Docket Item #10
BAR CASE #2005-0256

BAR Meeting
November 16, 2005

ISSUE: Additions and Alterations

LOCATION: 519 South Lee Street

Figure 2 Proposed North elevation

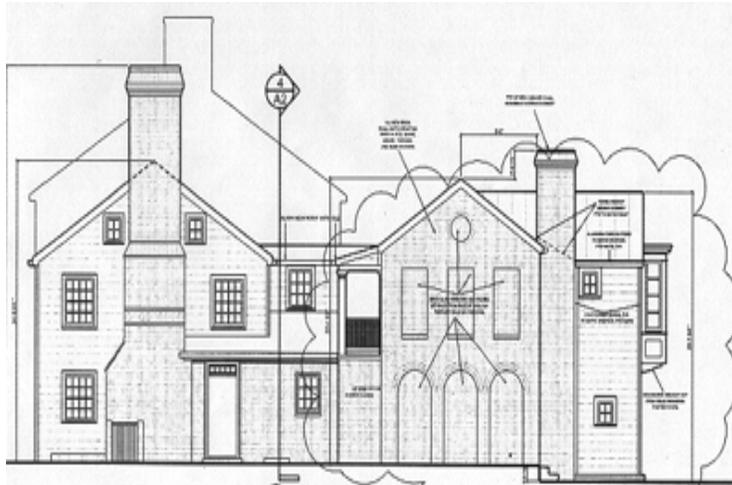
The applicant met with BAR Staff on two occasions to discuss the project. After listening to Staffs' comments, the applicant attempted to reduce the scale and mass of the new addition, so as to not visually overwhelm the rather small scale, historic two-story frame house. While Staff appreciates the efforts of the applicant, Staff is concerned that the addition as proposed still overwhelms the main house and should be reduced in scale. While the height of the addition is less than the height of the main house, the footprint of the addition is more than half the size of the existing footprint of the historic house and side porch. Also, by adding a second-story to the existing brick side porch, the massing of the additions appears even more overwhelming from the vantage point of South Lee Street.

The applicant's use of roof lines, windows light-configurations, and materials helps distinguish the addition from the main house. However, the proposed "beaded smooth" Hardi-plank is not recommended. While Hardi-plank may be used on new construction and additions, it should be a smooth finish. Staff would recommend that the Applicant use a smooth finish as a condition.

1. Call Alexandria Archaeology immediately (703-838-4399) if any buried structural remains (wall foundations, wells, privies, cisterns, etc.) or concentrations of artifacts are discovered during development. Work must cease in the area of the discovery until a City archaeologist comes to the site and records the finds.
2. The above statement must appear in the General Notes of all site plans and on all site plan sheets that involve demolition or ground disturbance (including sheeting and shoring and grading) so that on-site contractors are aware of the requirement.
3. The Hardi-plank on the new addition should have a smooth finish, not the proposed “beaded smooth” and the nails should not show in the installation of the siding.
